To: T10 Technical Committee
From: Rob Elliott, HP (elliott@hp.com)
Date: 10 July 2003
Subject: 03-214r1 SES-2 Update to SAS Device Element Status descriptor

Figure 1 — Filling in the Device Element Status descriptors

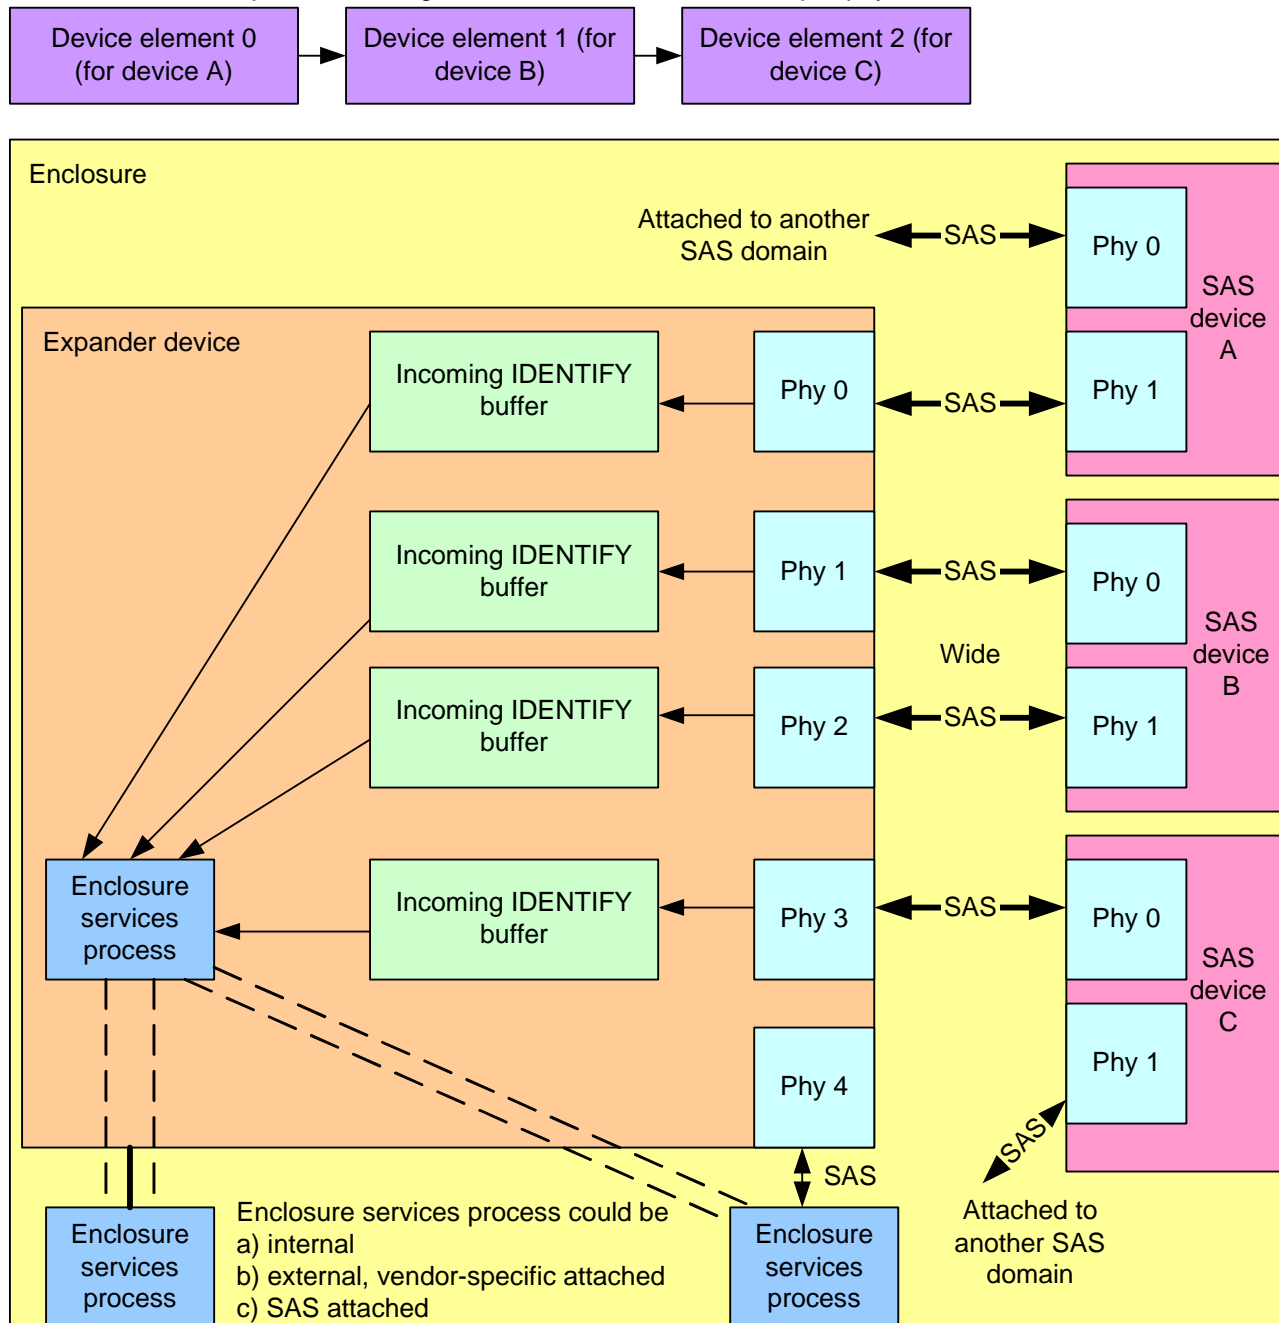
In this example, the enclosure services process knows there are 3 slots for SAS devices (based on the design of this enclosure), so it provides 3 Device elements (for A, B, and C). The slot for B uses a 2-wide physical link, showing that the element is for the device, not the port. The enclosure services process knows about phy 1 in SAS device A but not phy 0, since phy 0 is in another SAS domain, so the Device Element Status descriptor cannot include any details about phy 0. It knows about both phys in SAS device B, so can fill in information about them. It only knows about phy 0 in SAS device C.

If the enclosure service process has access to both domains (e.g. it is itself a dual-port SAS device attached to both expanders), it might know about phy 0 of device A and phy 1 of device C and be able to report more information.

The proposed descriptor allows the enclosure process to report any phys it knows about regardless of domain. The NUMBER OF PHYS field is replaced by NUMBER OFPHY DESCRIPTORS, and the phy identifier is included in the descriptor, so all phys need not be reported. The protocol bits are included to help figure out if it is a SCSI or ATA device; the attached SAS address is included to determine which domain each phy is in.
